UDFCD Maintenance Eligibility Program Referral Review Comments

Project: **Compark Village South Filing 1 – Belford Bridge**
Stream: **Happy Canyon Creek**
UDFCD MEP Phase: **Design**
UD MEP ID: **106582**

As Constructed	BELFORD-HAPPY CANYON CREEK		Project No./Code
No Revisions:	HAPPY CANYON CREEK DROP STRUCTURE		
Revised:	Designer: CDT	Structure	Sheet Number 74
Void:	Detailer: KLT	Numbers	
	Subset: Drainage	Sheets: DD-10 of 19

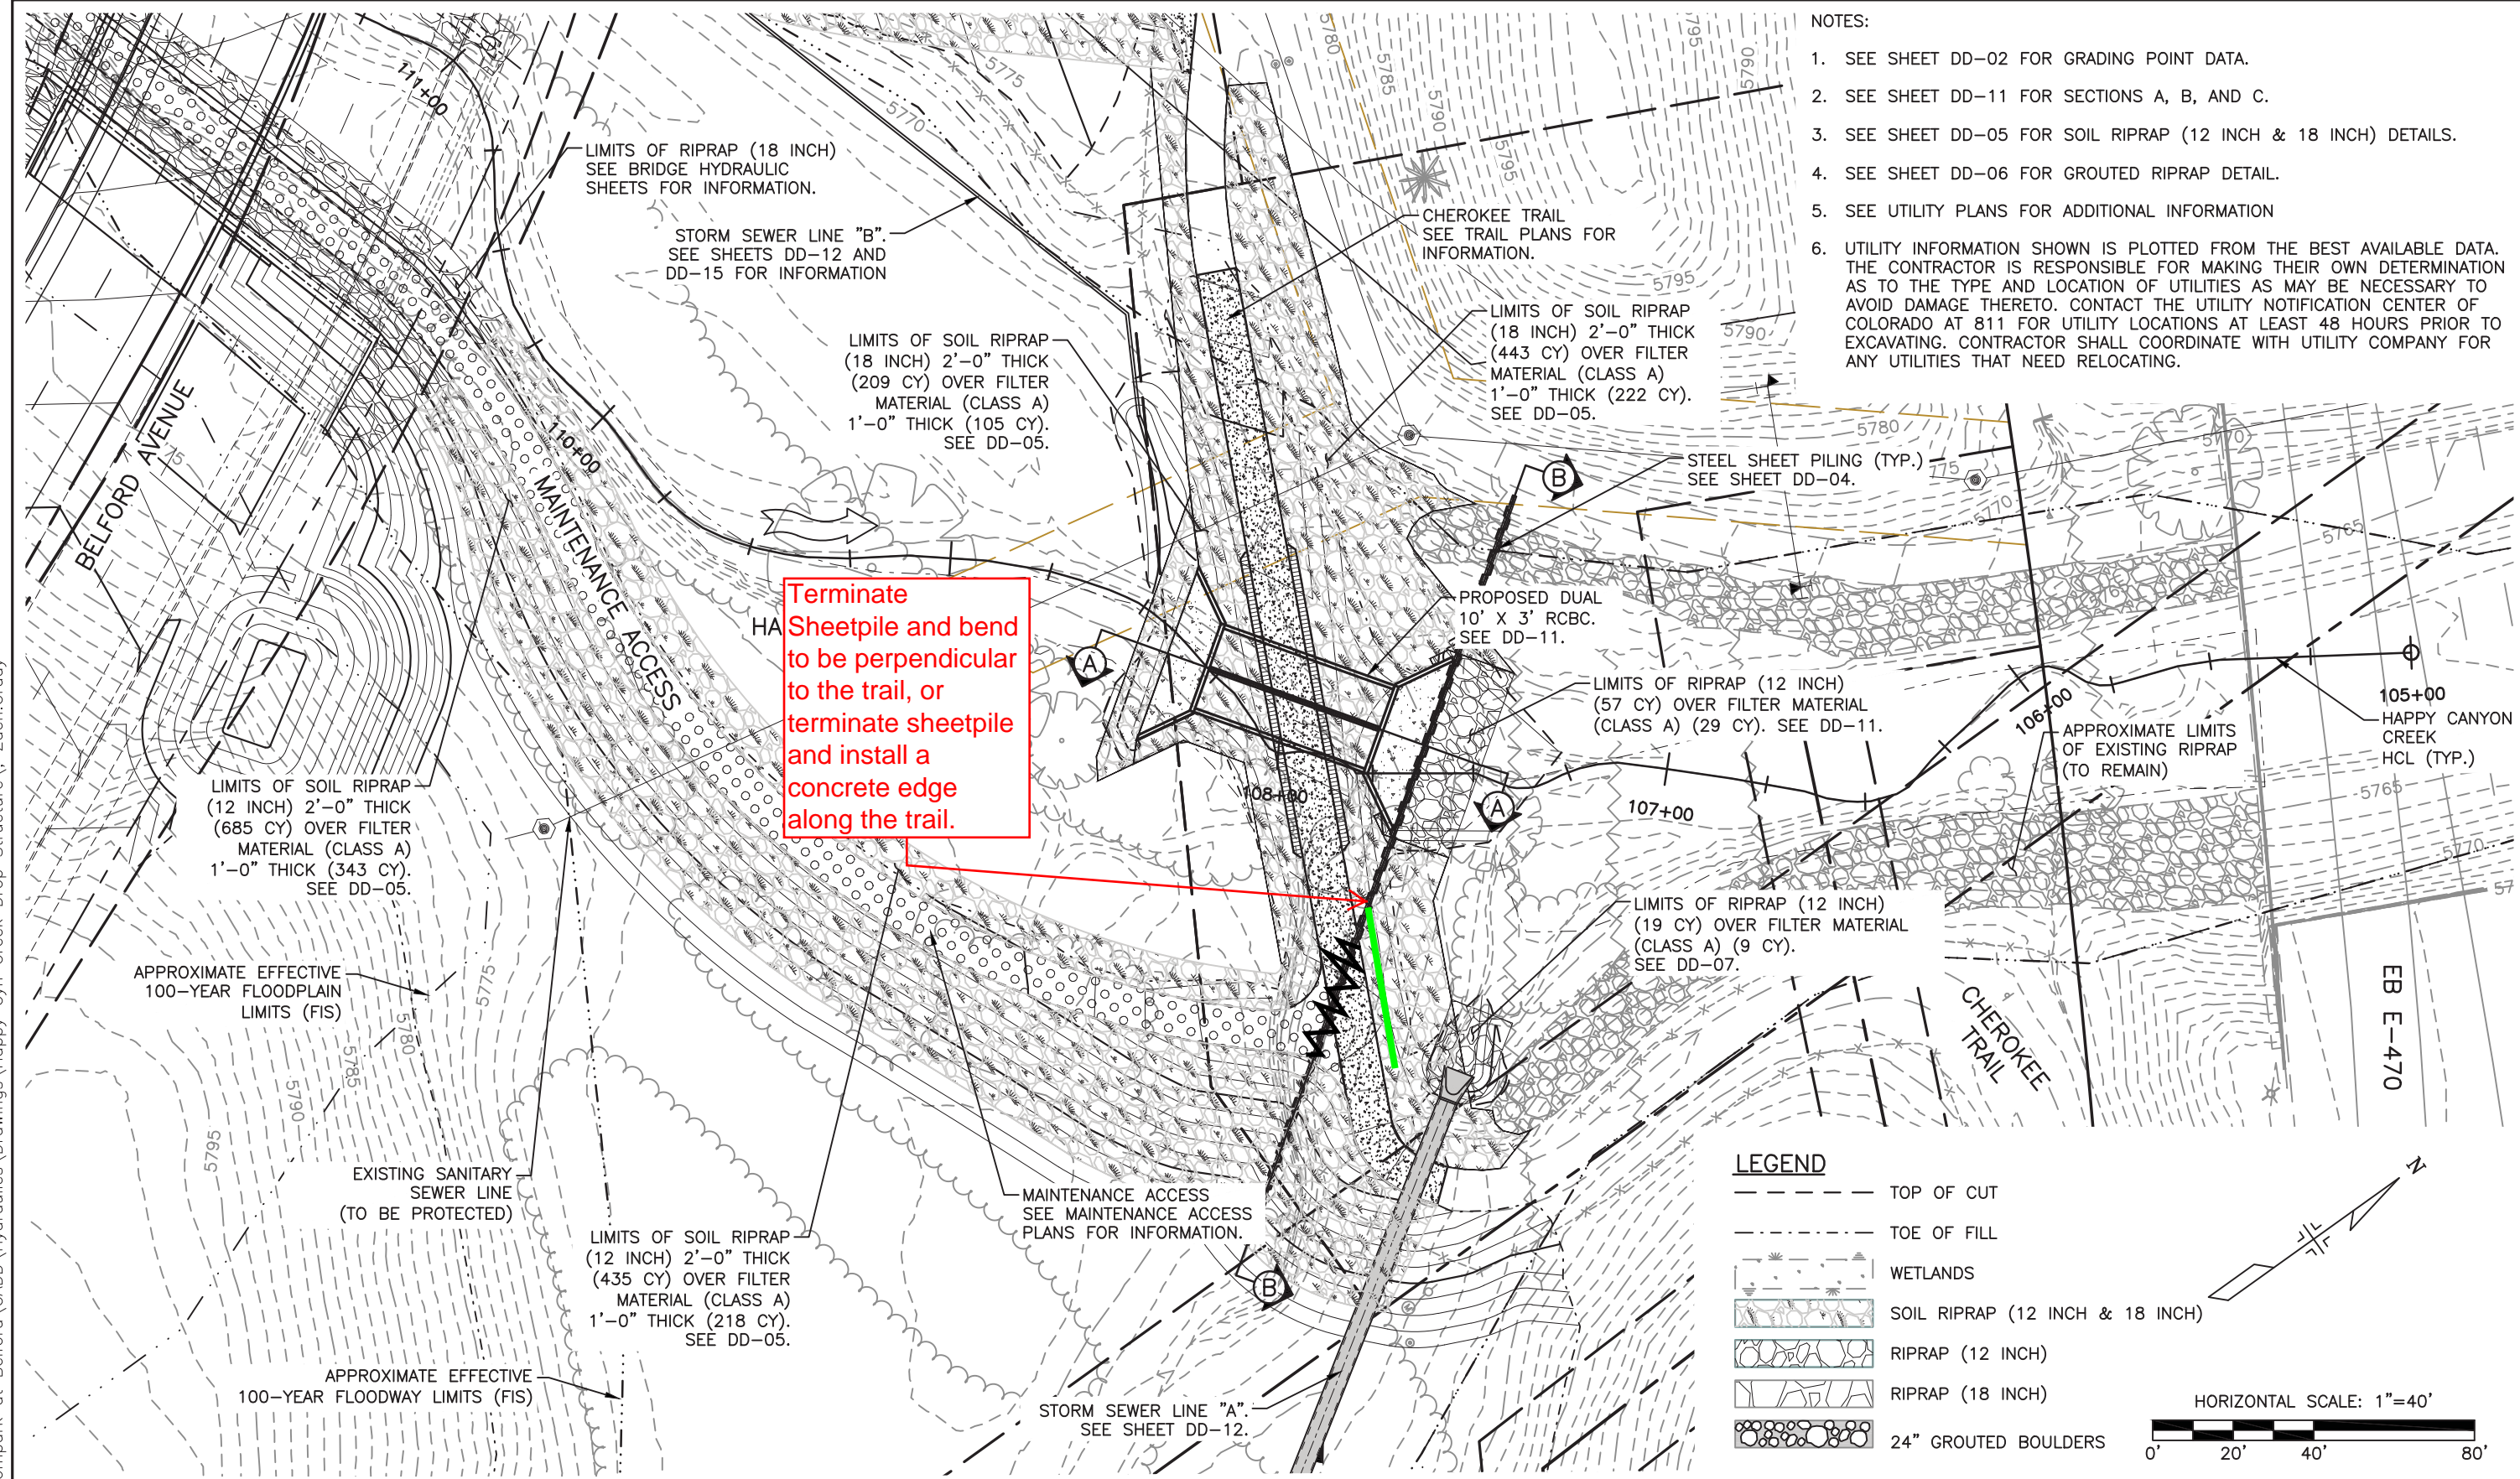
3. Please see the attached recommendation for the cutoff wall downstream of the low water crossing.
4. Please add the approximate ground water location to the drop structures profile and details. If the drop cannot be constructed to the plan depth due to ground water, than a grouted boulder drop with a stilling basin and end sill may be required.

Terminate Sheetpile and bend to be perpendicular to the trail, or terminate sheetpile and install a concrete edge along the trail.
